# LORSON RANCH

## A PLANNED UNIT DEVELOPMENT FOR CARRIAGE MEADOWS SOUTH AT LORSON RANCH FILING 2

CARRIAGE MEADOWS SOUTH AT LORSON RANCH FILING NO. 2
El Paso County, Colorado
PUD & PRELIMINARY PLAN

COVER SHEET

#### NOISE WALL DETAIL

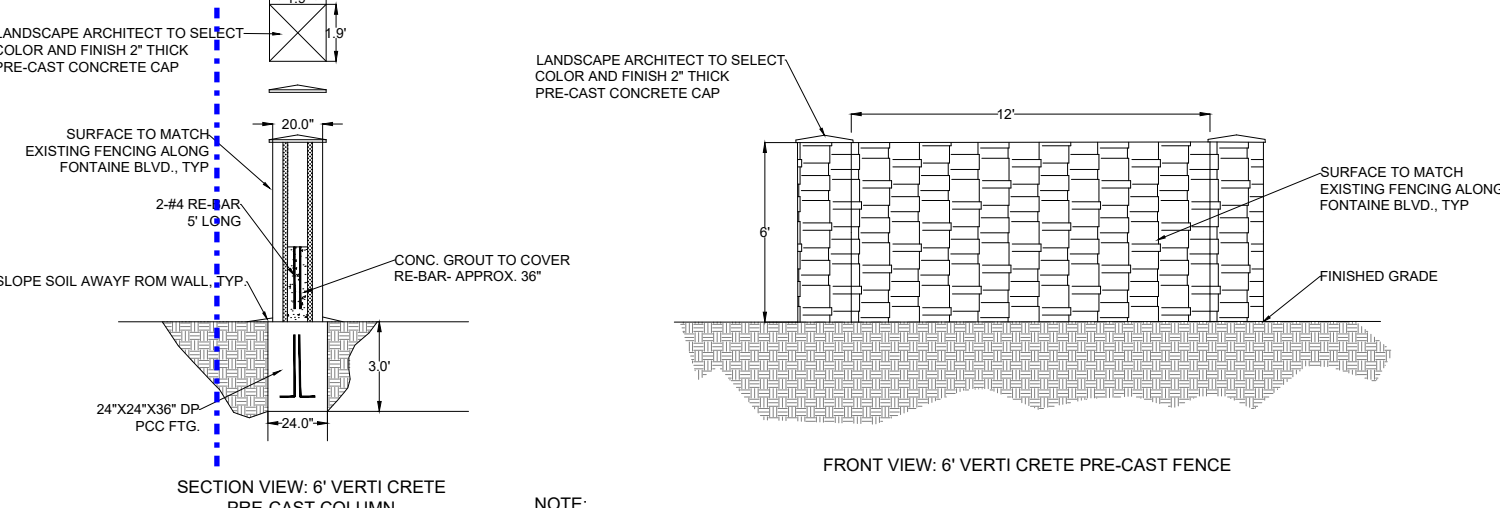
6' WOOD FENCE (EXISTING ADJACENT TO SOUTHERN BOUNDARY, SHEET P4) and northern?

label distance outside of ROW

along the Fontaine ROW and edge of property

**TYPICAL SECTION 50' ESMT RESIDENTIAL URBAN LOCAL**  
NOT TO SCALE  
RUBICON TRAIL (PRIVATE STREET)  
FIRESTEEL TRAIL (PRIVATE STREET)

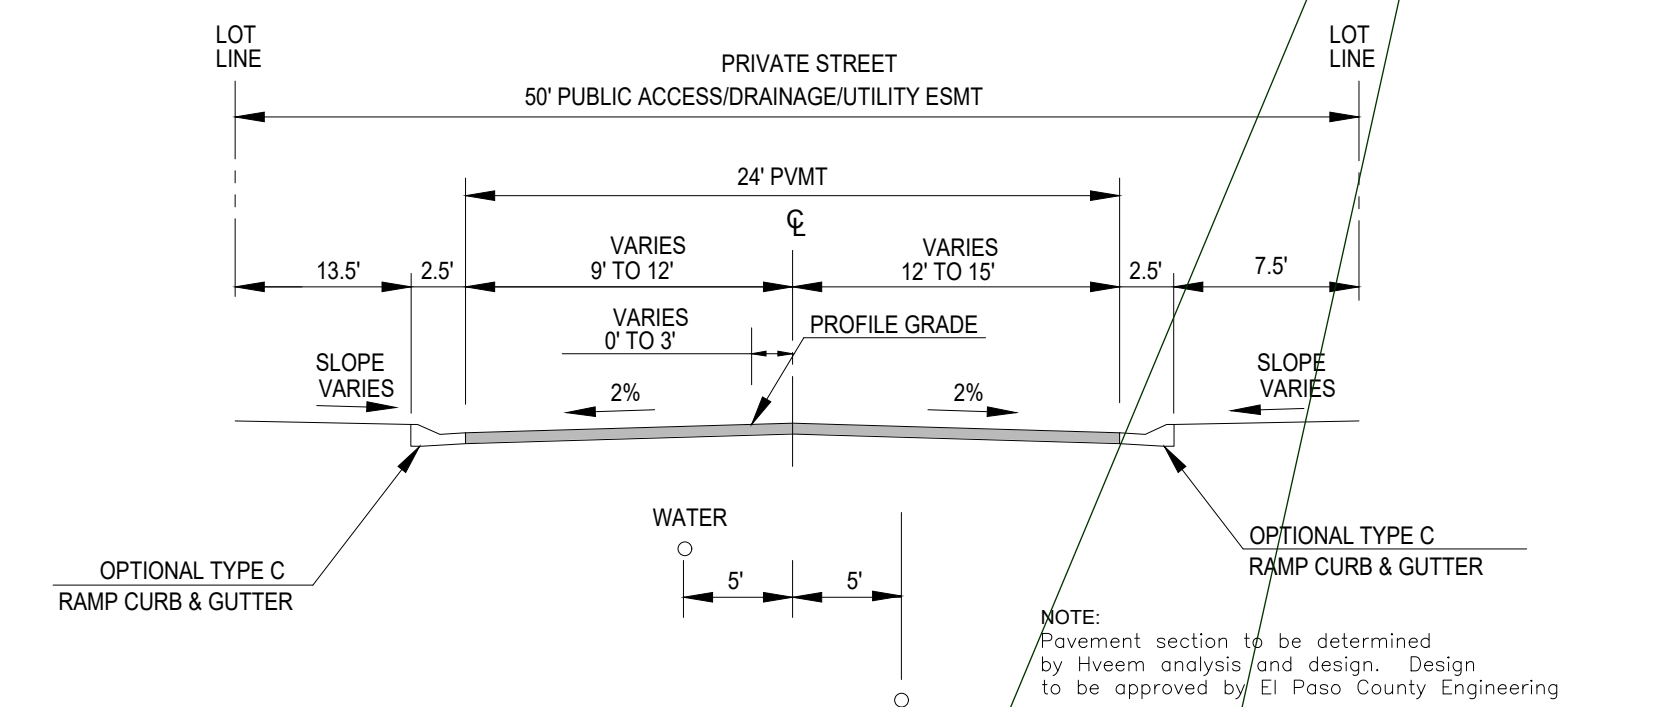
all these comments pertain to each detail to the right:

dimension ALL these details- check to make sure they work with your dim standards and the Code req before resubmitting

**TYPICAL SECTION 40' ESMT PRIVATE DRIVEWAYS 1, 2, 3 (lots 1-24)**  
NOT TO SCALE  
CHAGRIN TRAIL (PRIVATE STREET)  
PALUXY TRAIL (PRIVATE STREET)  
TOLT TRAIL (PRIVATE STREET)

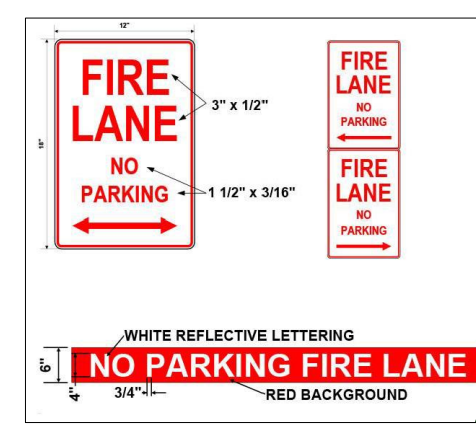
**FIRE LANE SIGNAGE DETAIL**  
NOT TO SCALE  
STAFF CONCERN: If no parking in driveway and no parking on street-where do the people park? when visitors come over or teenagers vehicles? Parking seems inadequate

### TRACT MAP & TABLE

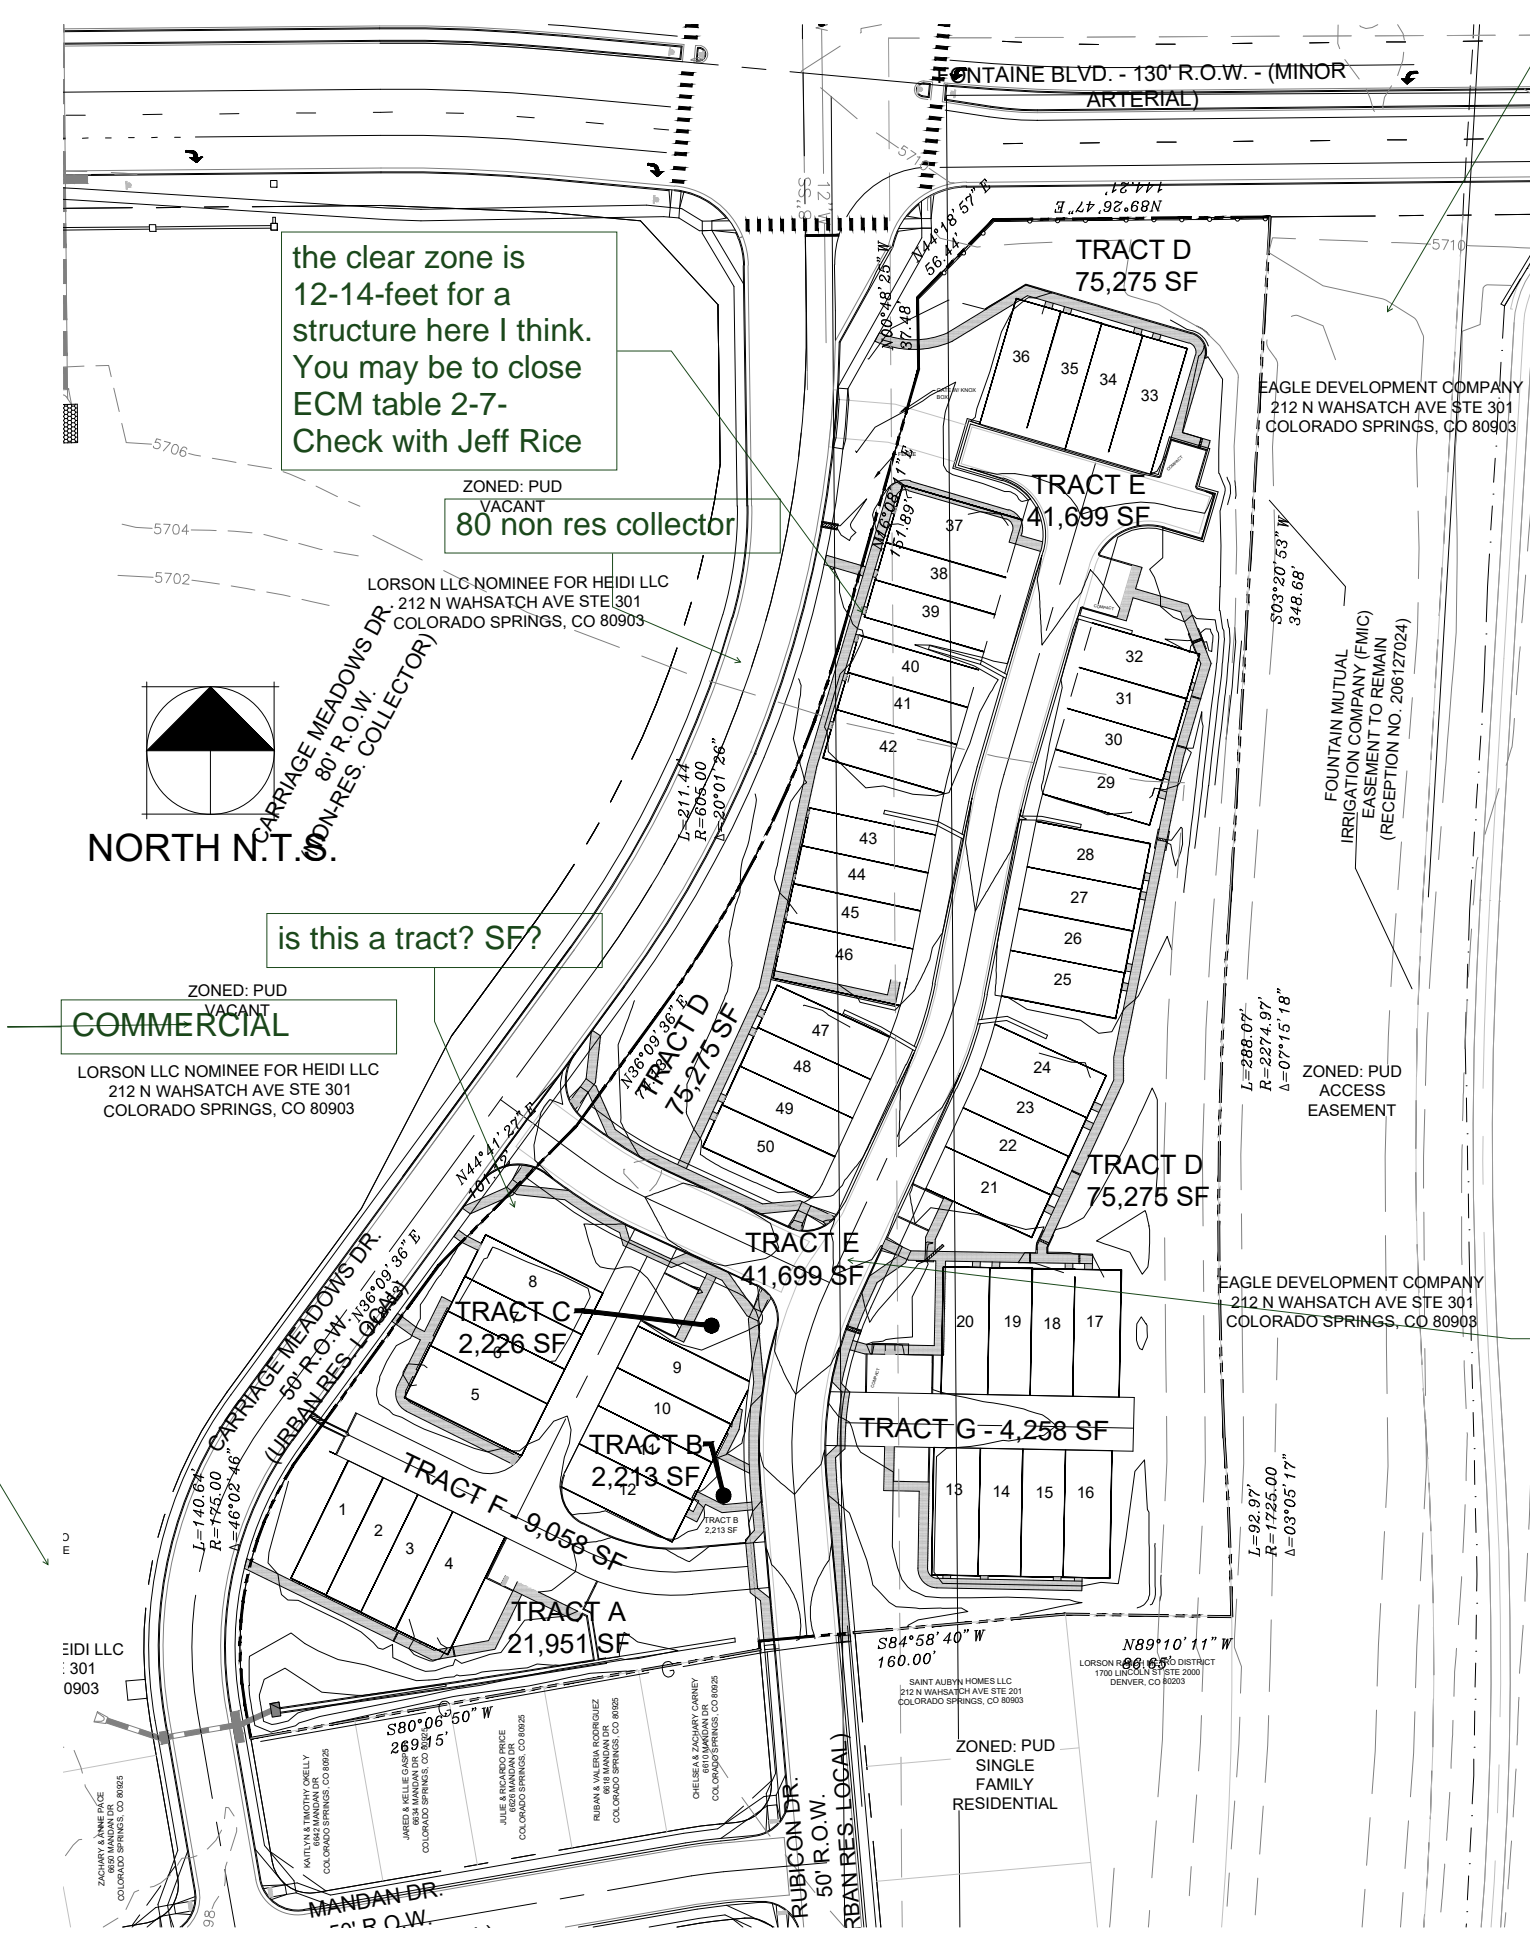
25% of the 10% must be for openspace parkland not drainage per Code...

hatch the pavement tracts so we can clearly see the open space -drainage tracts- THIS sheet only. I think were missing some tracts as they should close like the lots.

### TYPICAL LOT DIAGRAMS

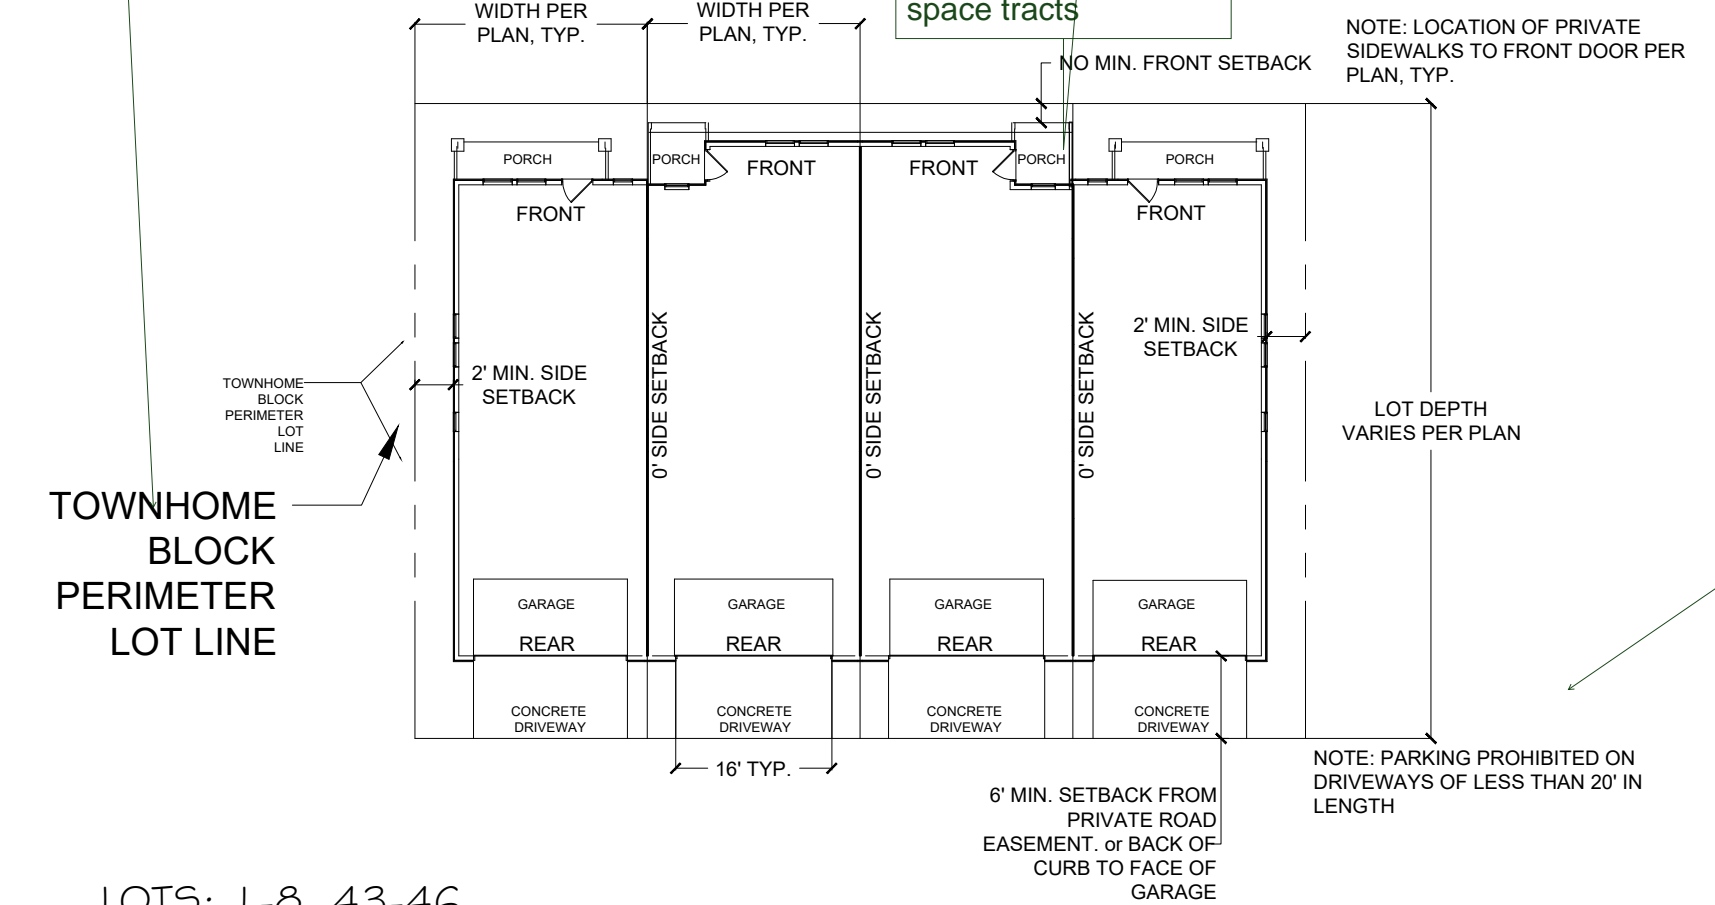
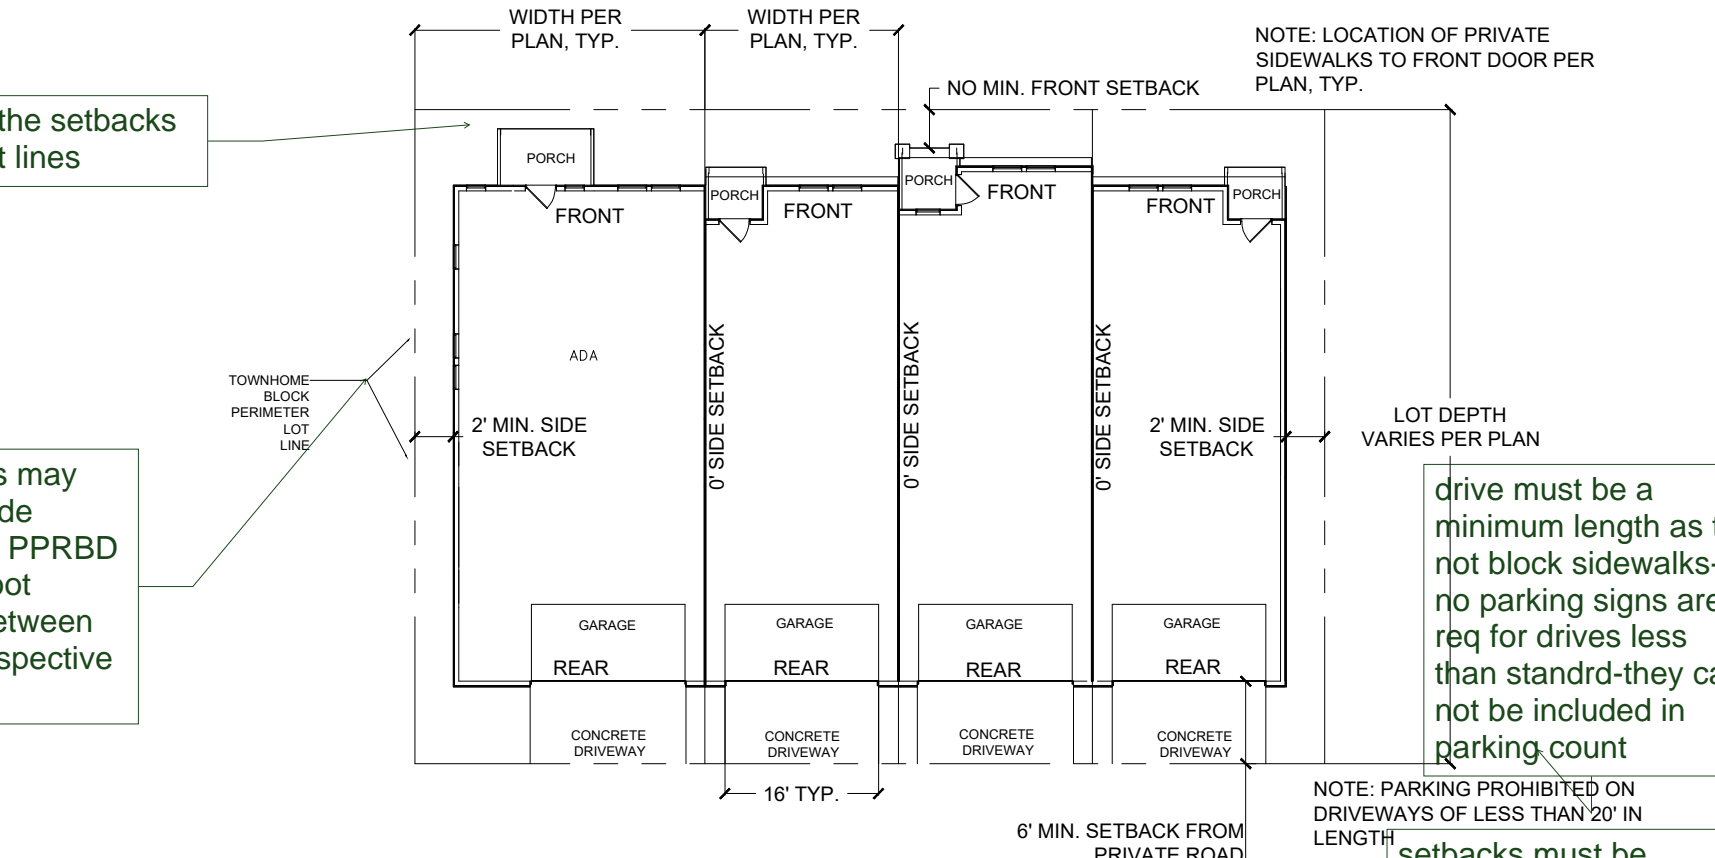
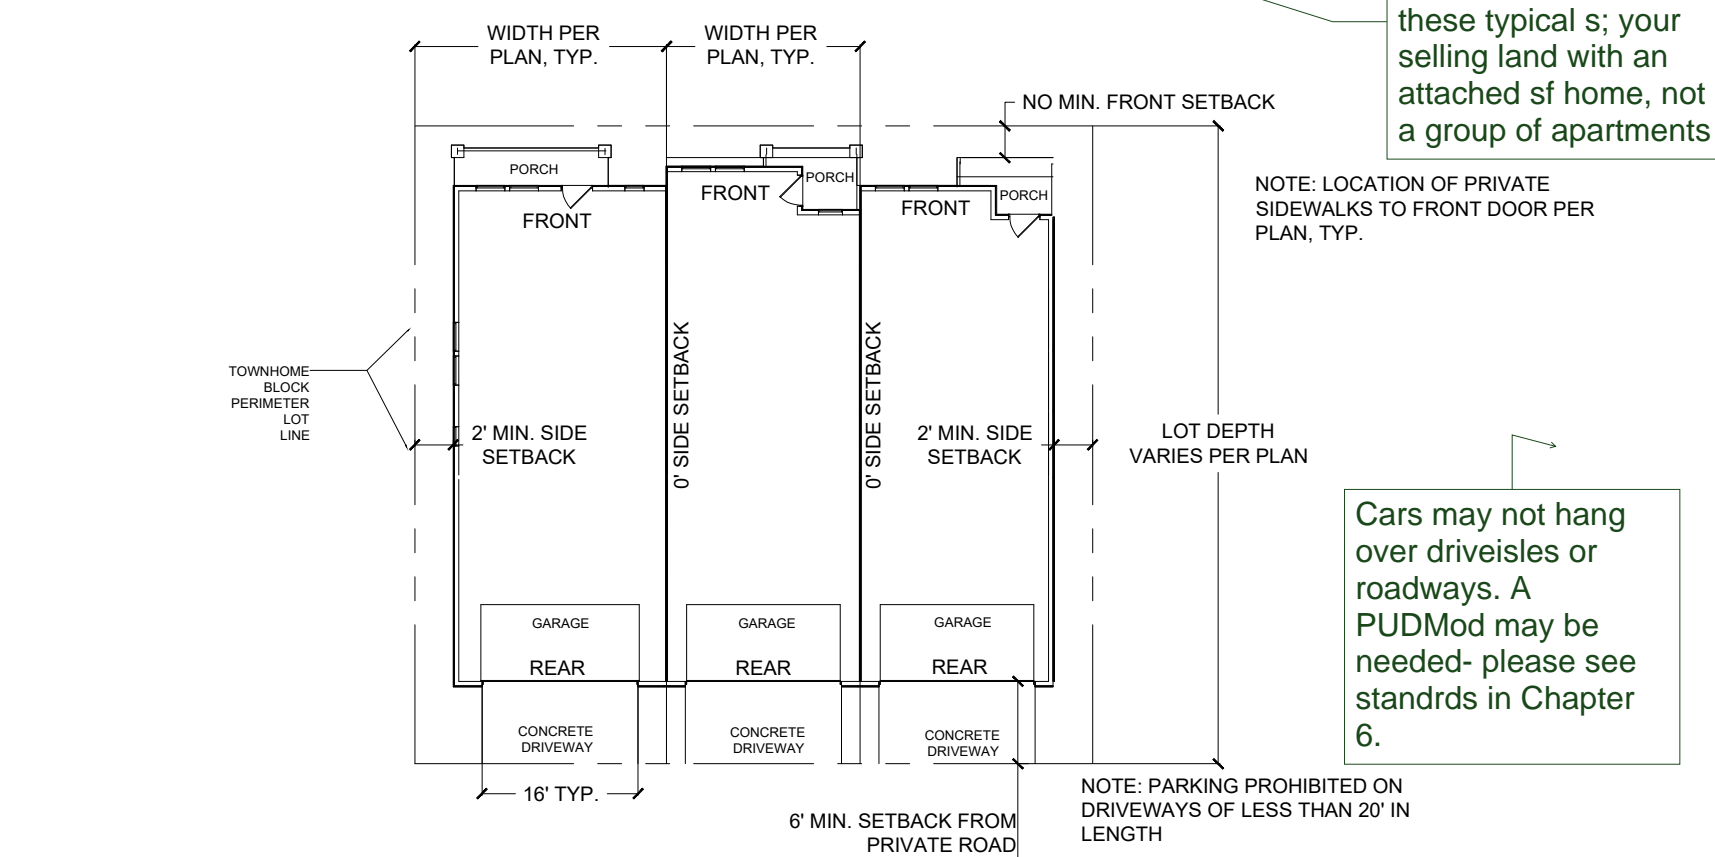
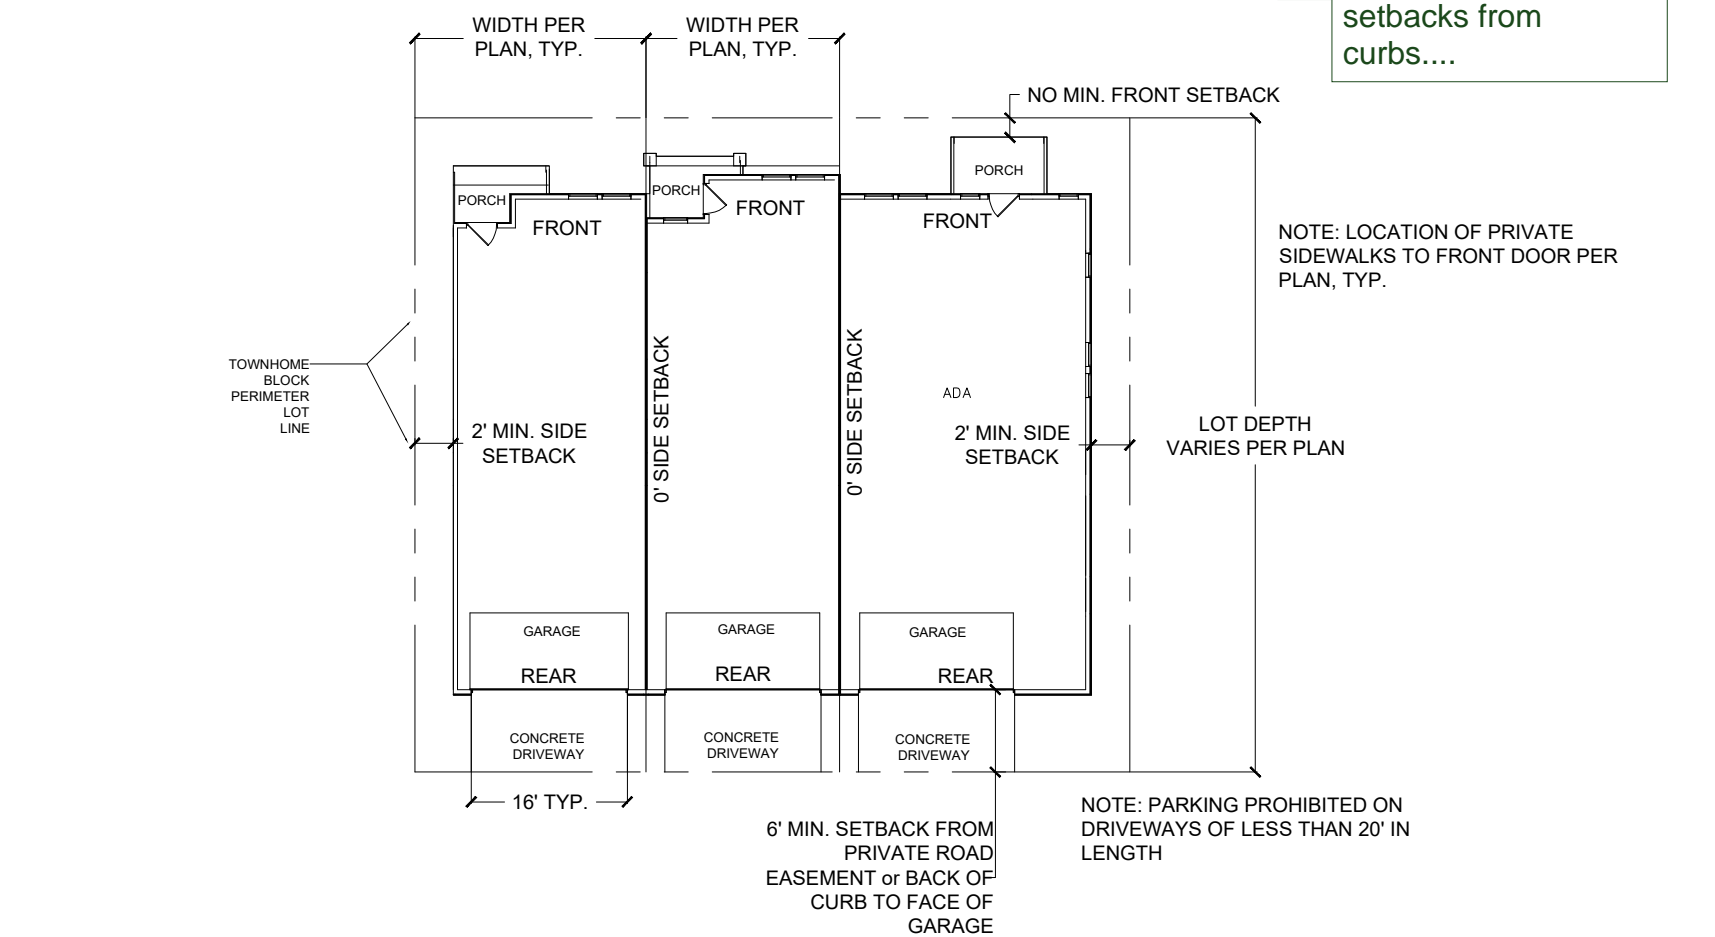
provide the setbacks to the lot lines

The end units may need 5foot side backs. Does PPRBD require 10- foot separation between buildings irrespective of lot lines?

how will the utilities fir in with no setbacks? Where are the easements for utilities per lot?
